UNITED STATES
NUCLEAR REGULATORY COMMISSION
WASHINGTON, D.C. 20555-0001

August 30, 2017

SUBJECT: OCONEE NUCLEAR STATION, UNITS 1, 2, AND 3 – SAFETY EVALUATION REGARDING IMPLEMENTATION OF MITIGATING STRATEGIES AND RELIABLE SPENT FUEL POOL INSTRUMENTATION RELATED TO ORDERS EA-12-049 AND EA-12-051 (CAC NOS. MF0782, MF0783, MF0784, MF0785, MF0786, AND MF0787)

Figure 1 – Oconee SFP Levels of Monitoring

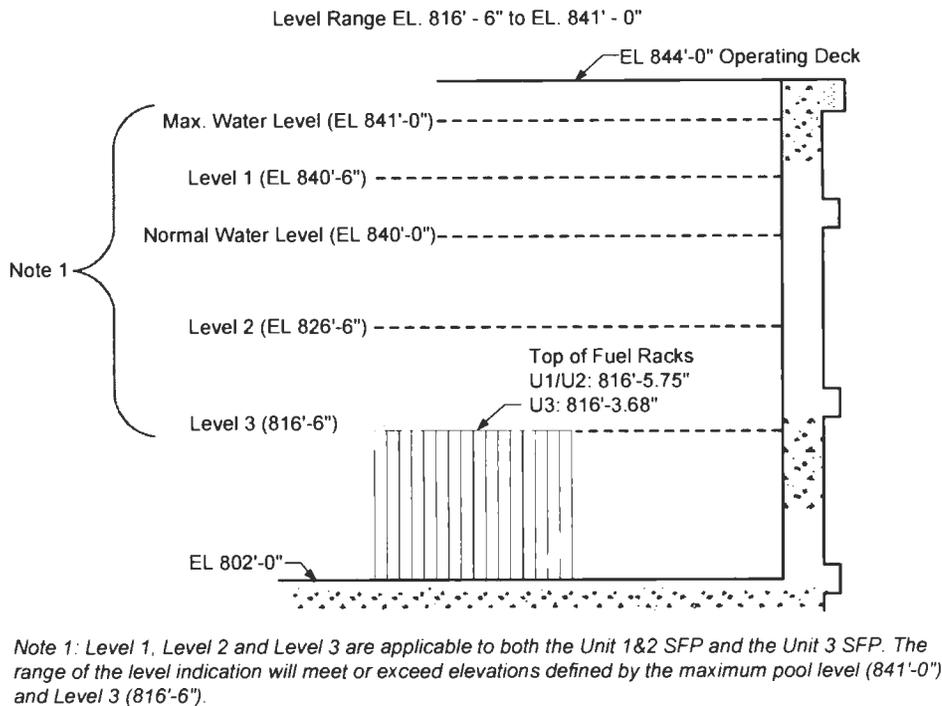
In its letter dated July 19, 2013 [Reference 26], the licensee revised Level 1 from EL. 837'-6" to EL. 840'-6" and stated that the normal SFP water level is EL. 840'-0". The SFP cooling pump suction piping submergence is lost when water level decreases below EL. 836'-0" (Point A). During normal operation, SFP cooling pumps are automatically tripped at EL. 837'-6" to protect against NPSH and vortex concerns. However, as the SFP temperatures increase above normal, including temperatures that approach saturation conditions, the SFP cooling pump flow rates are procedurally controlled to prevent operation with potentially inadequate NPSH or vortex conditions based on engineering analysis. Under these high temperature and reduced flow conditions, the limiting level which provides protection against inadequate NPSH or vortex conditions is EL. 840'-6", which is 6 inches above the normal SFP water level. Due to the design of the SFP suction piping, pump operation cannot be supported at all during saturation conditions in the pool. Thus, Point B for Oconee can only be approximated by the point at which NPSH protection is provided, which varies dependent on SFP conditions. Under normal conditions, Point B relates to EL. 837'-6". But as SFP temperatures approach saturation, Point B relates to EL. 840'-6". Therefore, Oconee will consider EL. 840'-6" as its "Level 1" datum due to it being higher than Point A and higher than EL. 837'-6".

In its letter dated February 29, 2016 [Reference 35], the licensee provided a sketch depicting the SFP levels of monitoring as illustrated below in Figure 1, "Oconee SFP Levels of Monitoring".

The NRC staff's assessment of the licensee's selection of the SFP levels of monitoring is as follows.

In its letter dated February 29, 2016 [Reference 35], the licensee provided a sketch (Figure 1, "Oconee SFP Levels of Monitoring") depicting the SFP sensor's measurement range from EL. 816'-6" to EL. 841'-0". The NRC staff noted that this measurement range covers Levels 1, 2, and 3 as described in Section 4.1 above.
